Department of Energy

**Ohio Field Office
Fernald Area Office**

TRANSMITTAL OF VARIANCES TO PROJECT SPECIFIC PLANS

This letter transmits for your records, variances to the following Project Specific Plans (PSP): PSP for Sampling of Soil Stockpile 5 for On-Site Disposal Facility (OSDF) Waste Acceptance Criteria (WAC) Attainment; Area 8 Phase I Certification Sampling, Rev 1; the Geotechnical Sampling and Testing Plan for the Southeast Borrow Area 1 Phase II; and the A2P1 Delineation of Areas Exceeding WAC. The variances do not involve a significant change in scope.

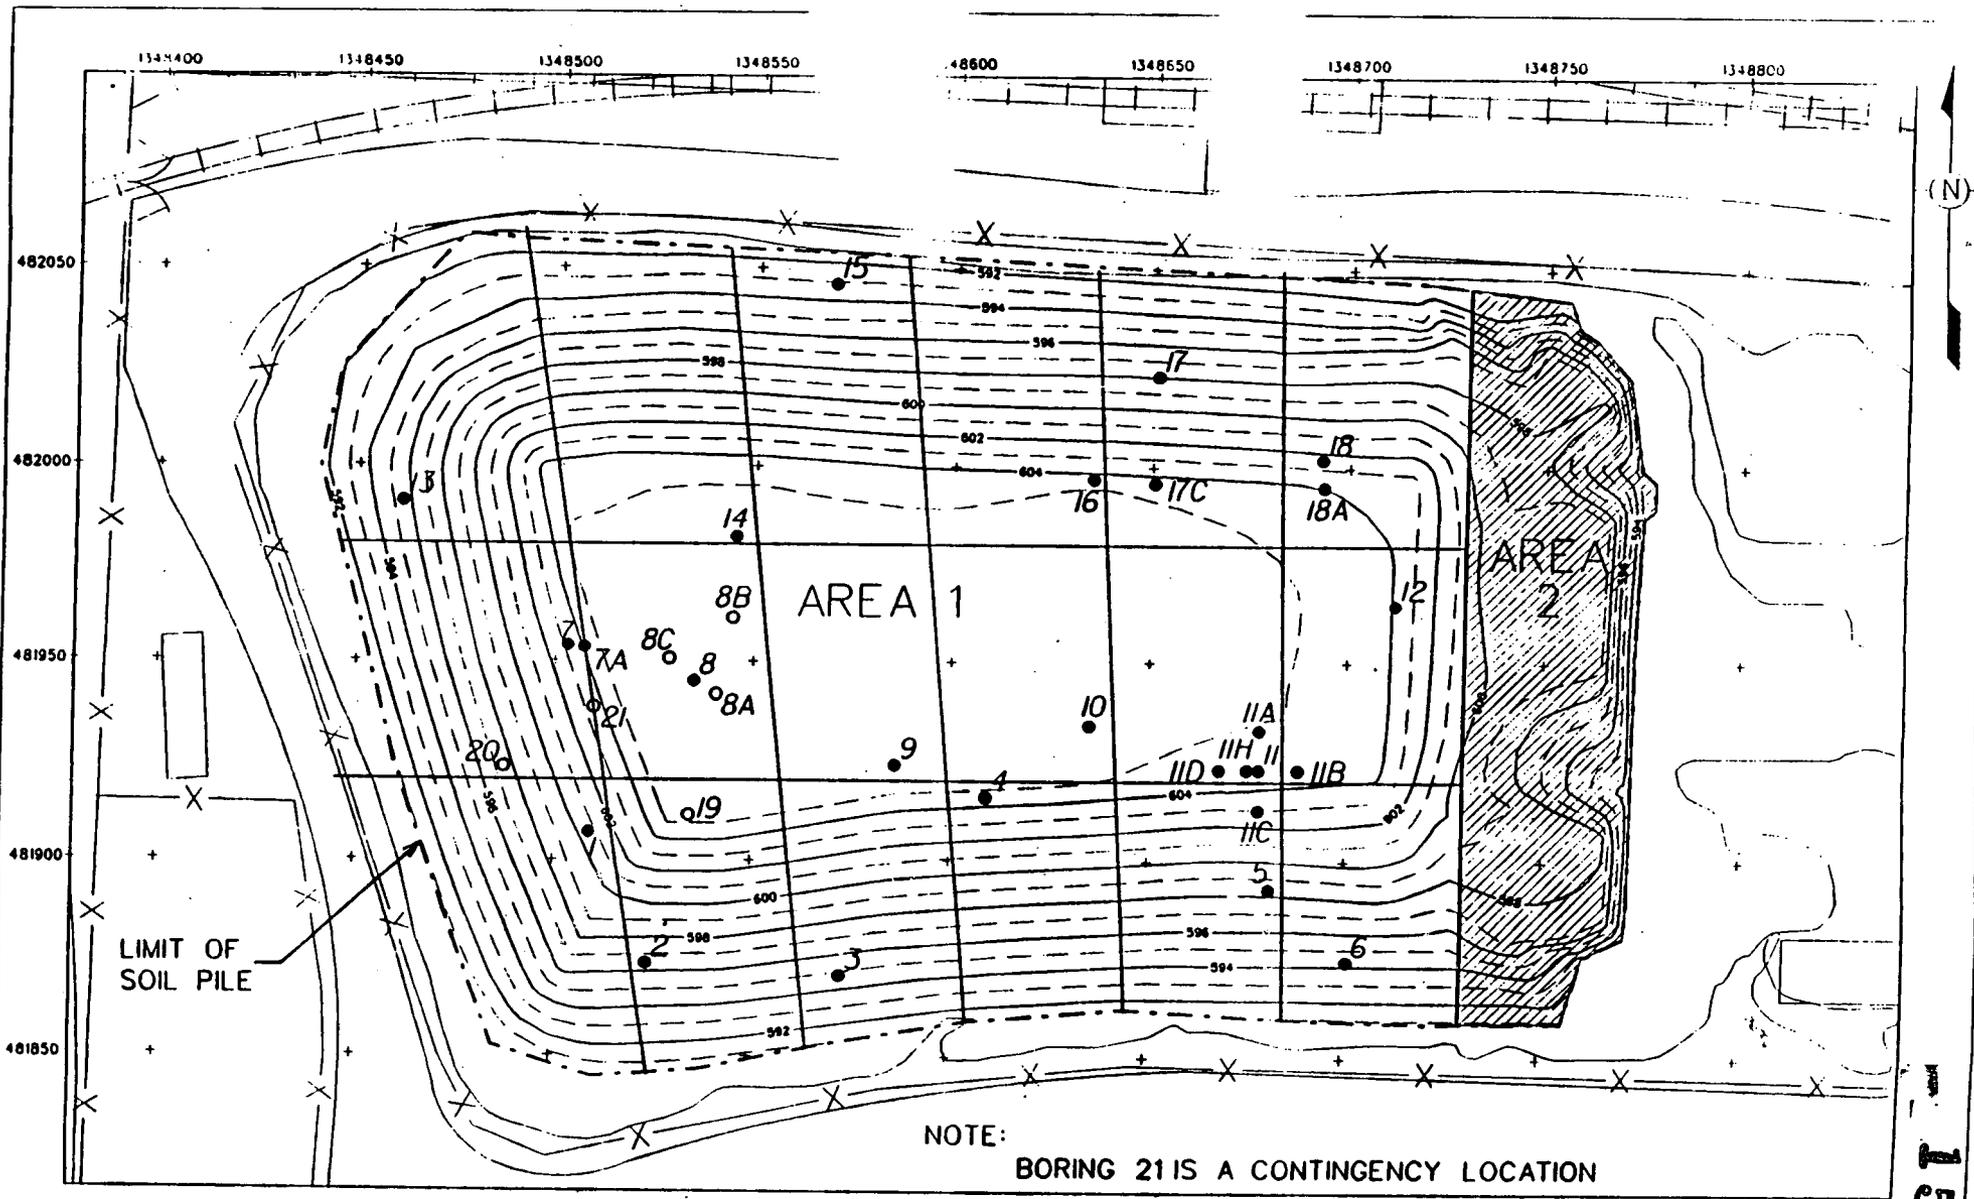
This variance describes additional samples to be collected from SP5 as stated in the PSP (Section 1.4) if above-WAC soils are encountered. Above-WAC soil for total uranium was detected in boring locations 1 and 8 of SP5 during the first round of sampling per the PSP as follows:

Additional borings will be located to encompass a triangular-shaped sector in the southwest corner of SP5 in order to bound the above-WAC soil horizontally and vertically. Five borings and one contingency location have been selected for soil coring and field screening as illustrated in Figure 2-2 attached.

Soil cores will be collected for the entire height of the pile at each of the five borings (and possibly contingency location 21) and each core will be surveyed with a beta-gamma probe (frisker). Any soil interval ≥ 100 ccpm will be collected by removing a 6-inch interval (bounding the ≥ 100 ccpm area) for total uranium analysis (TAL 50.03.52.03-B) per the PSP. As stated in the PSP, any debris in the core sample (e.g., concrete, wood, rubber, wire, etc.) that can be separated will be removed from the sample prior to containerizing.

An archive soil sample will be collected from each of the five borings at the 597.1 feet elevation (which is 6 inches above the >WAC interval in SP5-8) and archived for possible future analysis for total uranium. The archive sample intervals for the five borings are provided below. Also, archive samples will be collected above and below any interval exhibiting ≥ 100 ccpm for possible analysis in the future.
